PureThermal OpenMV Hardware Errata

Jan 11, 2024 - Version 2

Figure 1: This is damage caused by removing the battery connector without special care to avoid damage.

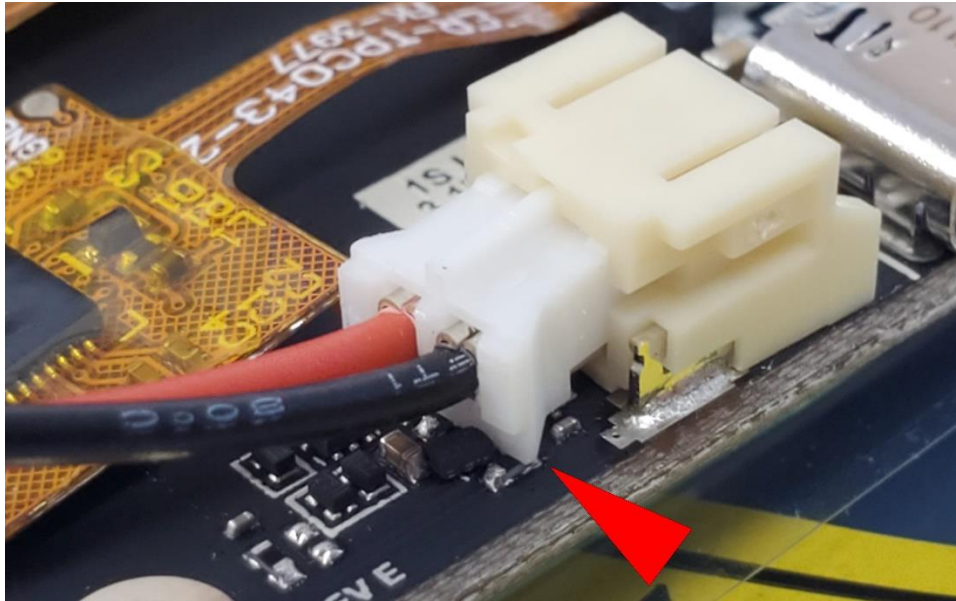
There are components beneath the battery connector which can come in contact with the battery cable end. Removing the cable can take components off the board with it.

Figure 2: This protruding wedge catches on components and should be removed.

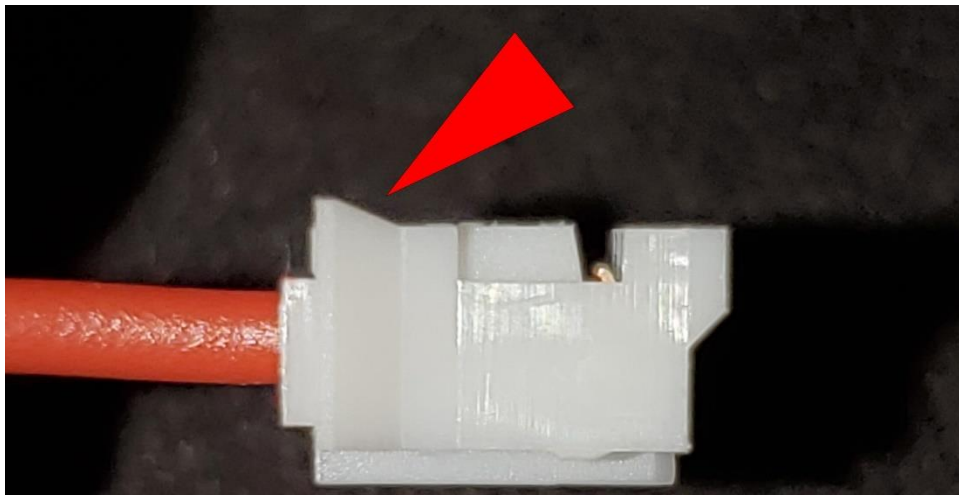
It is recommended to remove the protruding wedge from the battery cable connector with flush cutters before use. This will prevent risk of damage.

*Figure 3: C96 and C97 are circled in this schematic view.*

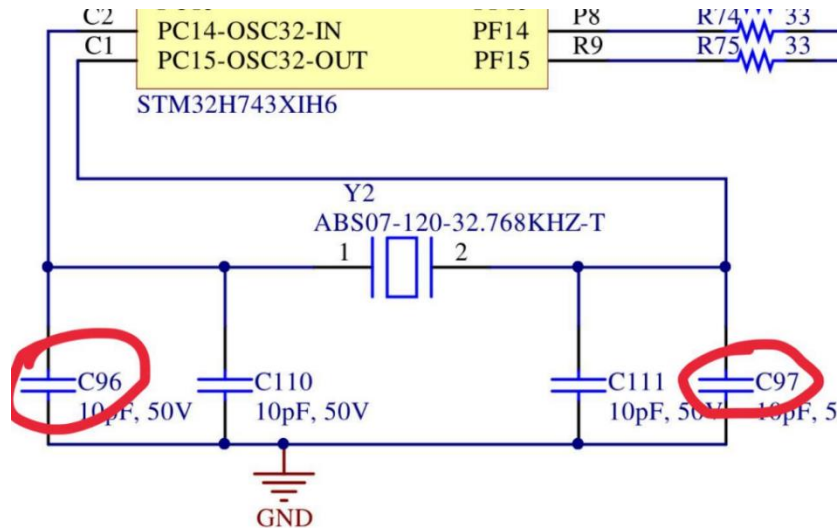
The load capacitance on the Y2 crystal is too high. Removing C96 and C97 can restore functionality to the RTC. These capacitors are already removed on most boards.

Figure 5: The LED indicates 'charging' even though the battery is fully charged.

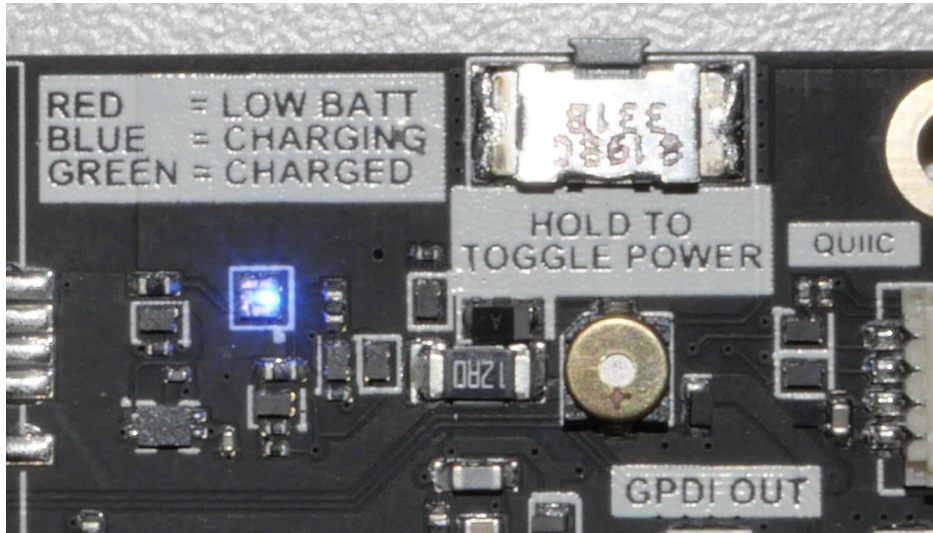
3. The charge indicator LED may not turn green when the battery is fully charged.

The battery charger may stop charging at 4.15V to 4.19V without triggering the green LED.

Figure 6: The silkscreen indicates this pin is VBAT, but this pin has no connection.

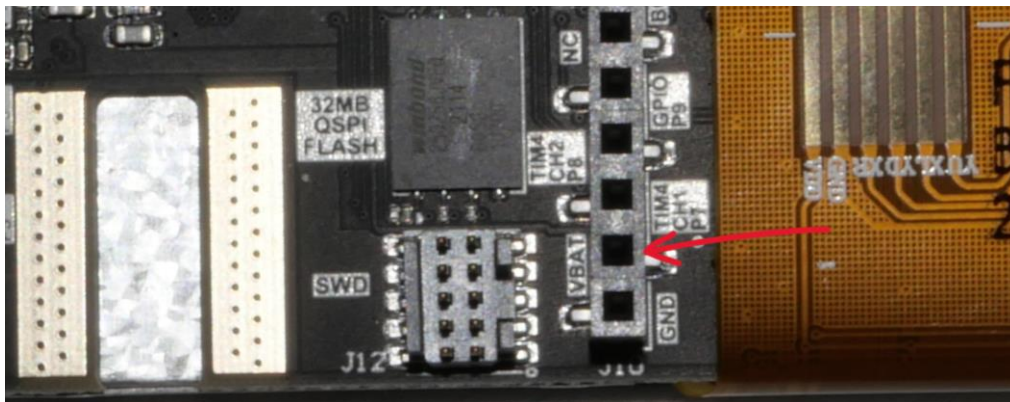
4. VBAT is unconnected on the I/Os.
